CERTIFICATE OF APPROPRIATENESS

Property: 8734 Glenloch Drive, Lot 4, Block 52, Glenbrook Valley Section 9 Subdivision. The property includes a historic 2,282 square foot, one-story brick veneer single-family residence with attached garage situated on a 9,040 square foot (80' x 113') corner lot.

Proposal: Alteration – In July 2014 the applicant replaced 14 original aluminum single lite fixed windows, 2 and 3-part single lite slider windows with 11, 9-lite slider, 6-over-6 sash windows, and a 3-part bay window, replaced the front entry door with a 9-lite front entry door, installed inoperable shutters, and replace the sectional overhead garage door with a new garage door without a City Permit or Certificate of Appropriateness.

HAHC Action: **Approved with Conditions:**

NORTH SIDE ELEVATION

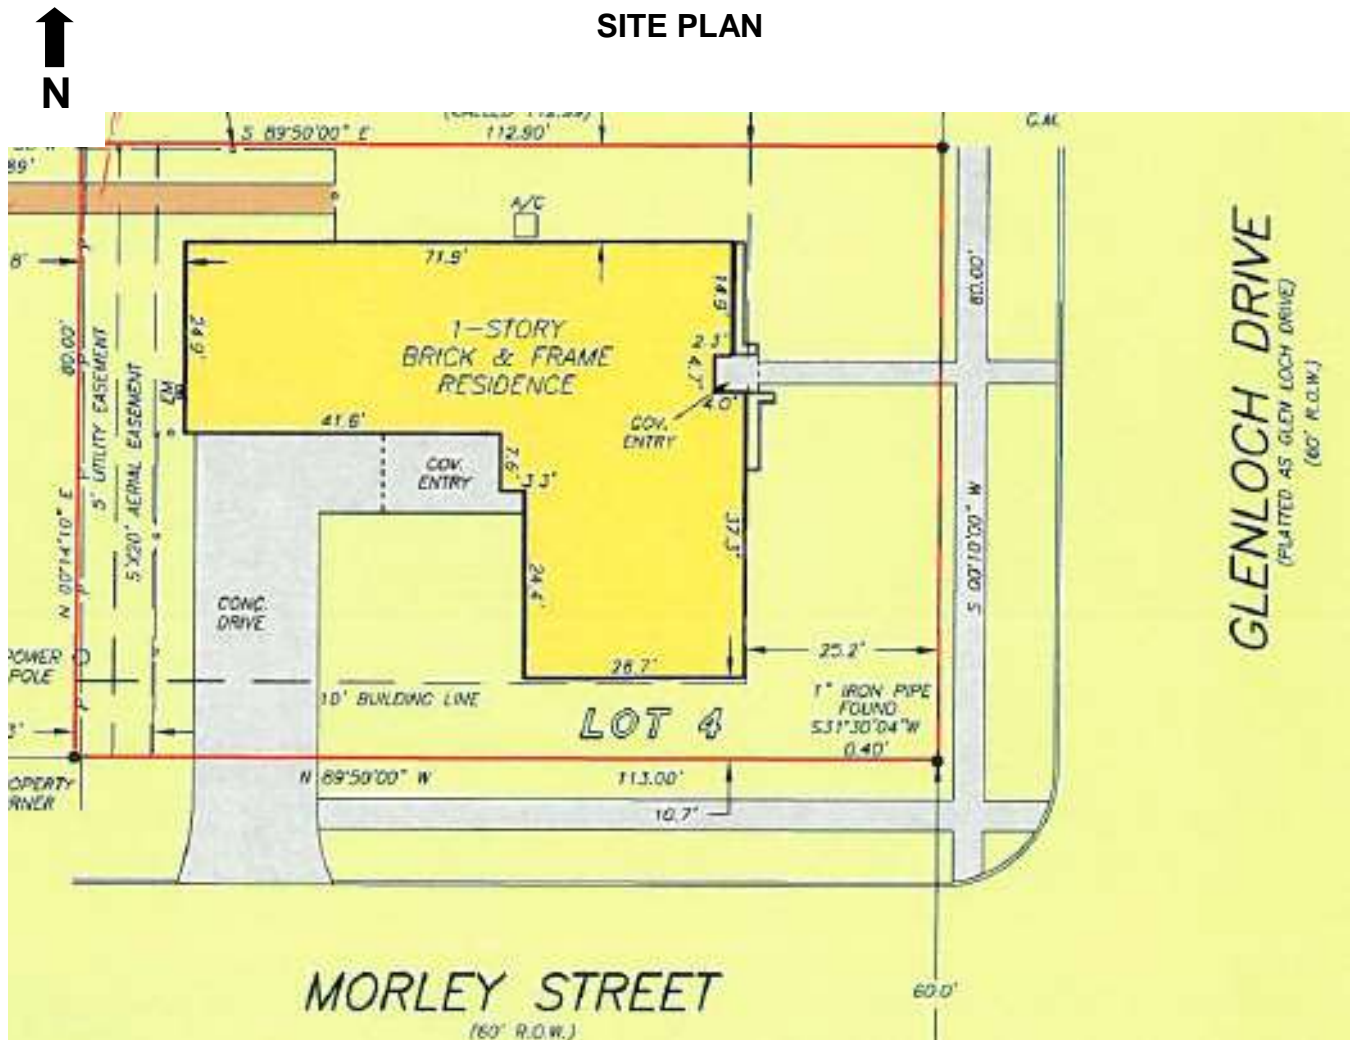
<i>The removal of the original aluminum windows and entry door results in the loss of historic material. The new divide lite windows along with the installation of the bay window alter the historic character of the Traditional Ranch.</i> |

<i>The installation divided lite craftsman style windows, shutters and bay window introduces new architectural features that are not compatible with and alter the character of the 1959 Traditional ranch.</i> |

Replace the existing 9-lite slider and divided lite sash windows with single-lite slider windows and 1-over-1 sash windows, remove the bay window and install 3, single lite windows to match the original condition; remove the inoperable shutters; replace the existing 9-lite entry door with an appropriate traditional ranch style door.

FIRST FLOOR PLAN WITH WINDOW LOCATIONS

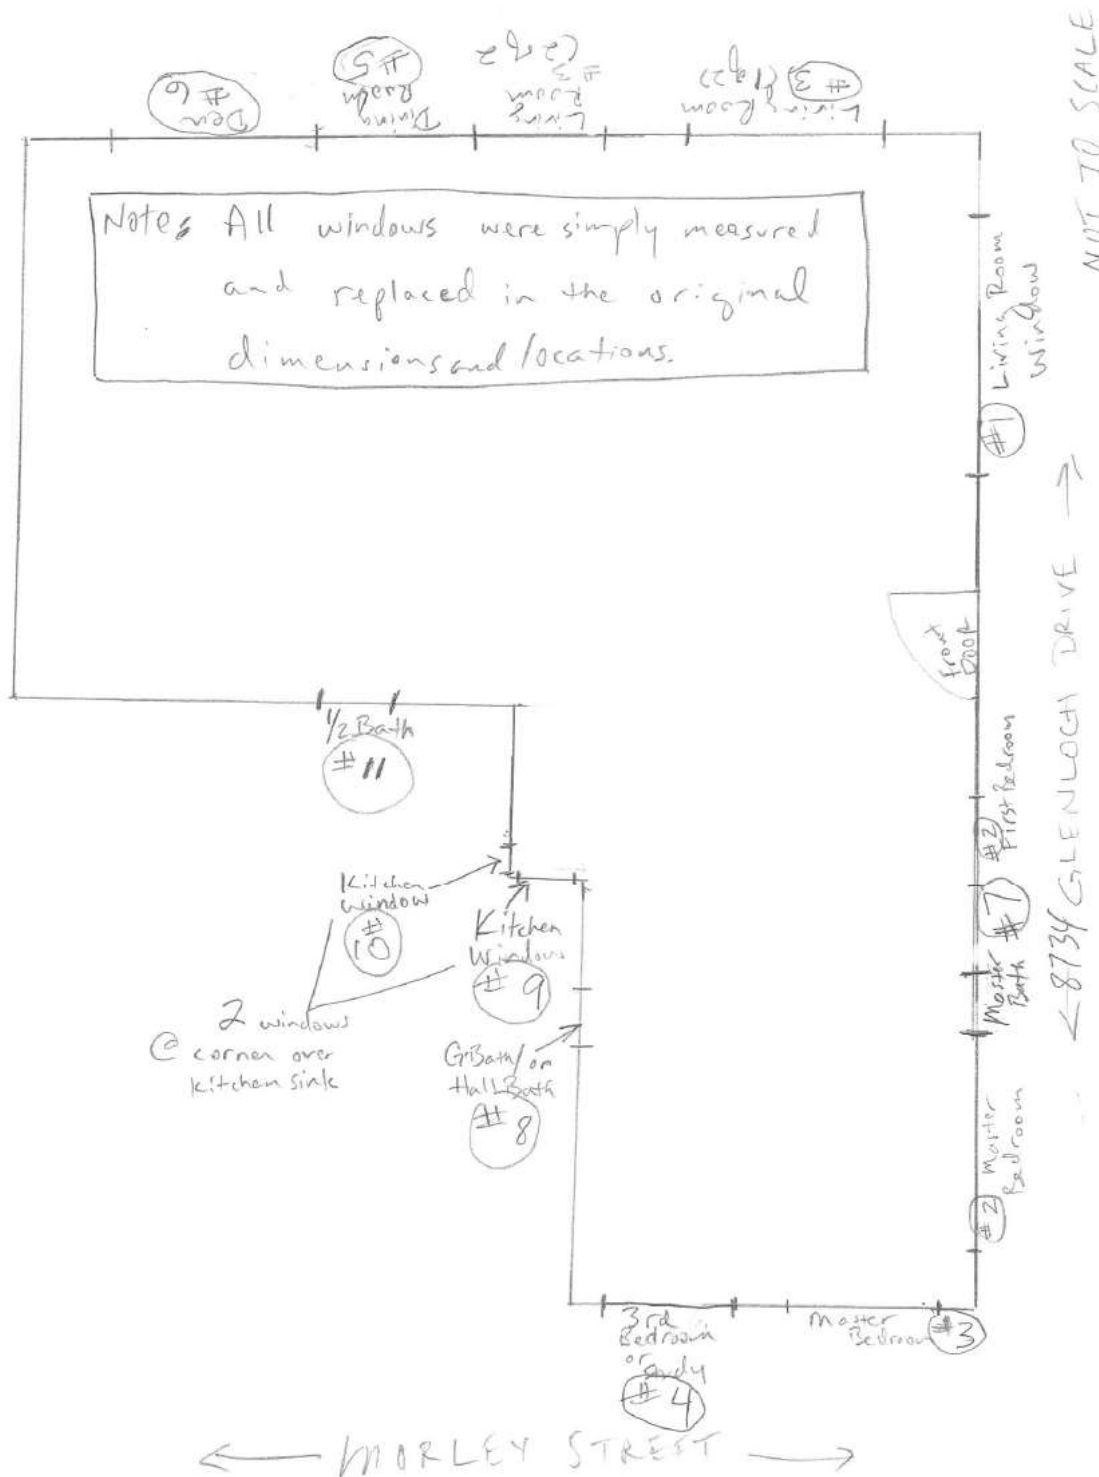
<i>The removal of the original single lite windows and solid entry door results in the significant loss of historic materials. The new divided lite windows with shutters along with the installation of the bay window introduce new architectural features and are not compatible with the historic character of the 1959 Traditional Ranch.</i> |

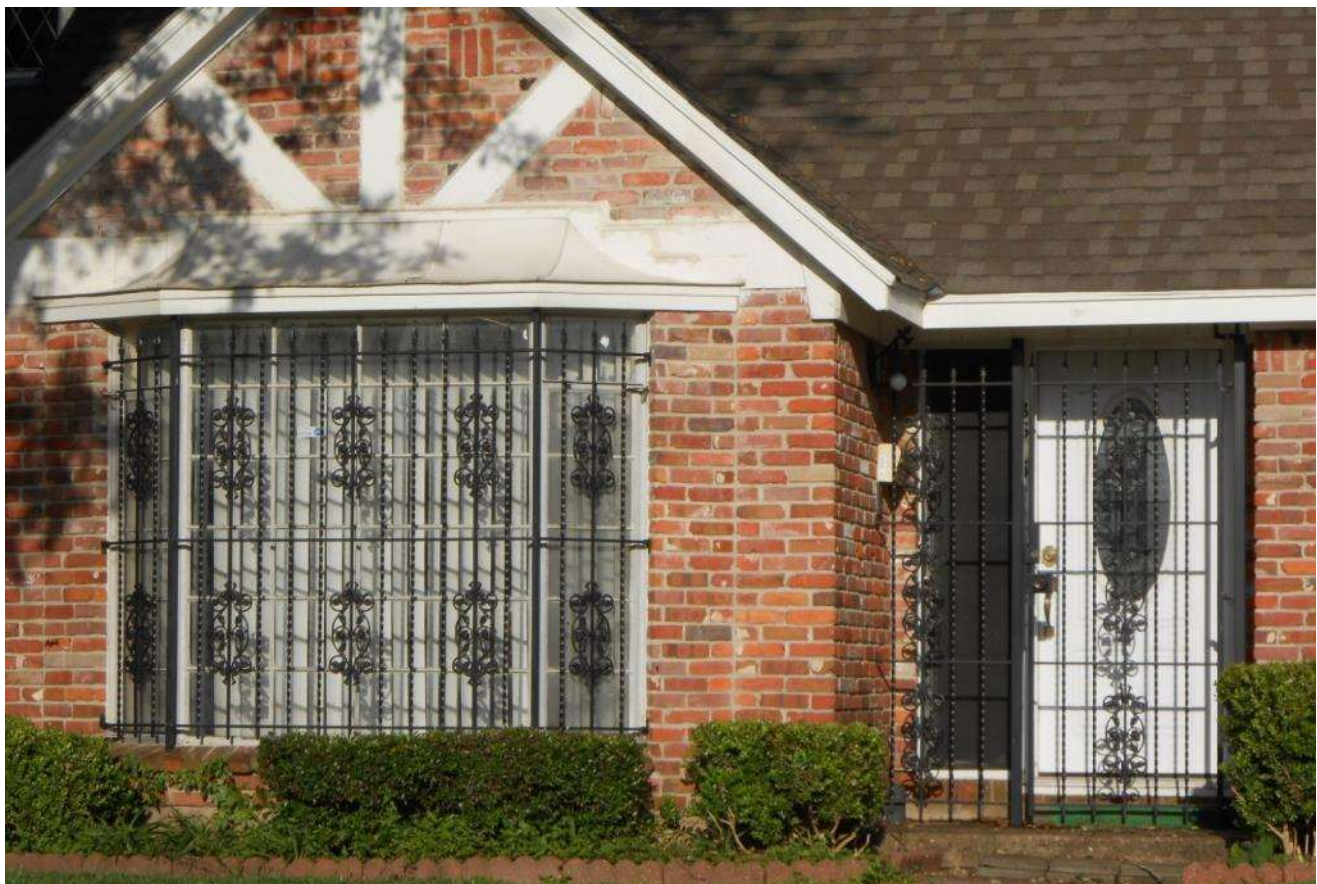
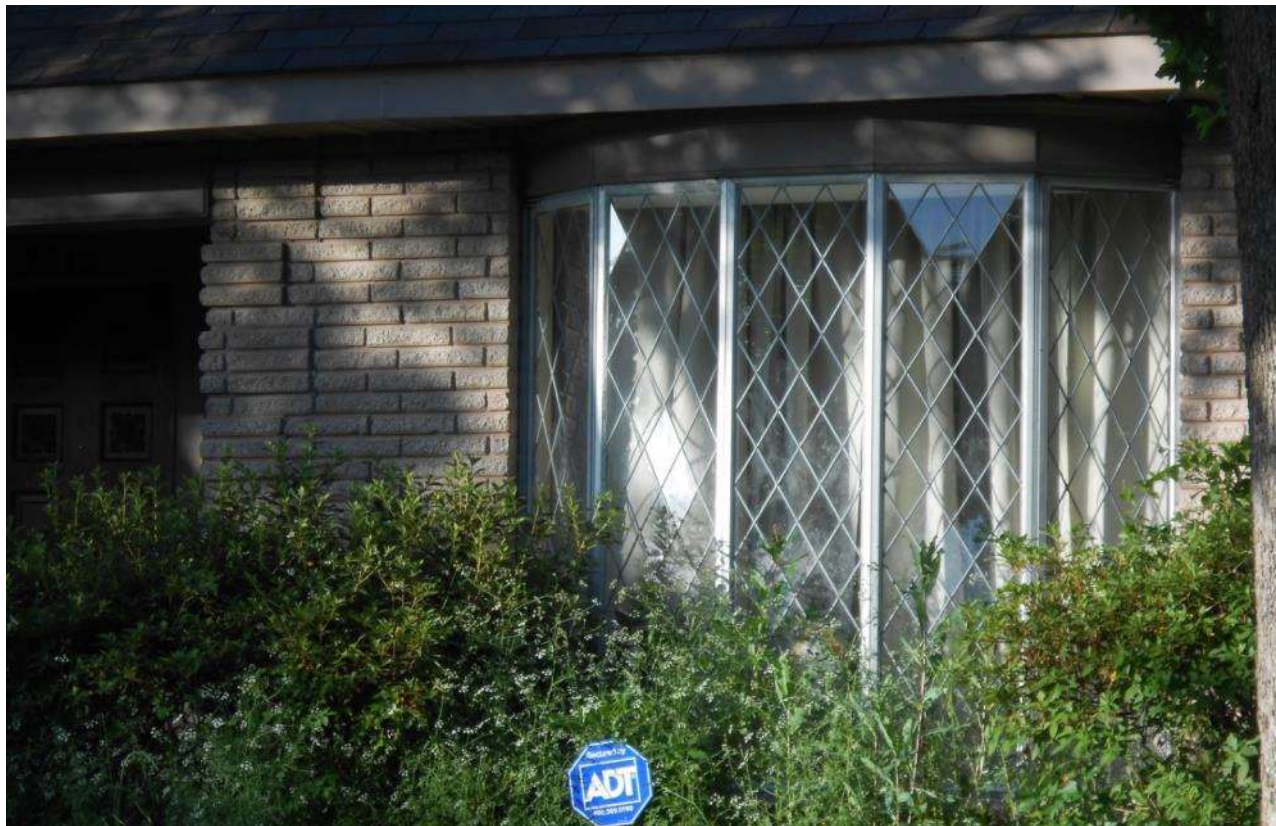
In lieu of submitting appropriate modifications, the applicant has provided photographs that mischaracterize the structural components of other homes in the District. Specifically, the applicant has submitted photos of inoperable shutters and bay windows that were original to their structures and equates original diamond pane windows and diamond screening to the faux "craftsman" mullions in the installed/submitted windows.
